INFORMATION BULLETIN

Wednesday August 6, 2014

Equipment: ICON Controllers - 188e Board (6300KY14) and I/O Expansion Board (6300JG2)

Figure 1 - 188e Board (6300KY14) Tag

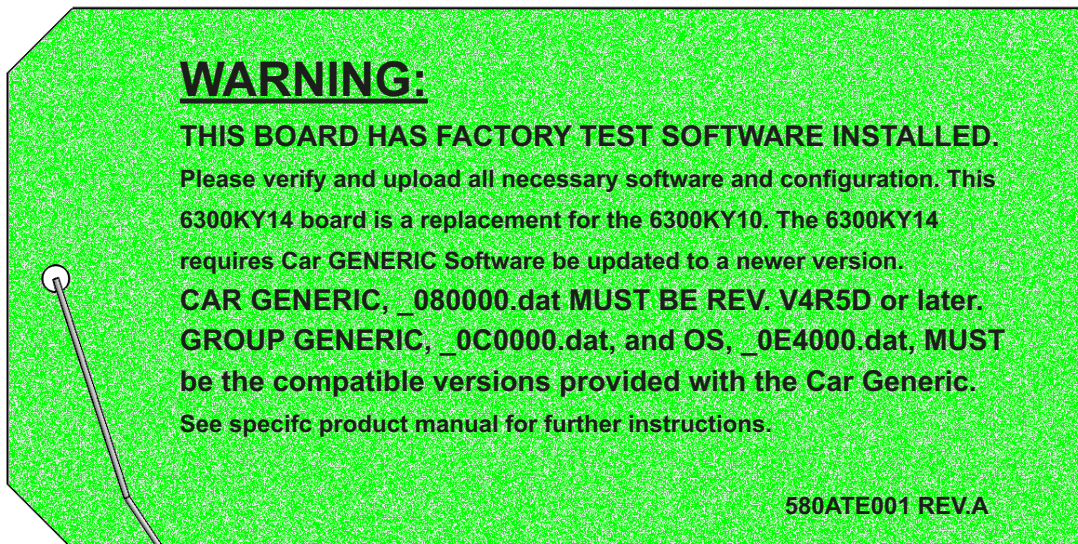
Information: These replacement boards are not compatible with older versions of generic software.

1. When replacing faulty 188e and I/O Expansion Boards, verify this information:
 - a. 188e Board (6300KY14)
 - The attached tag on the replacement board matches Figure 1 on page 2.
 - The part number on the board is 6300KY14.
 - b. I/O Expansion Board (6300JG2)
 - The attached tag on the replacement board matches Figure 2 on page 2.
 - The part number on the board is 6300JG2.
2. Install V4R5D generic software.

Note: V4R5D generic software is compatible with all 188e circuit boards and all I/O expansion boards, regardless of their part numbers.
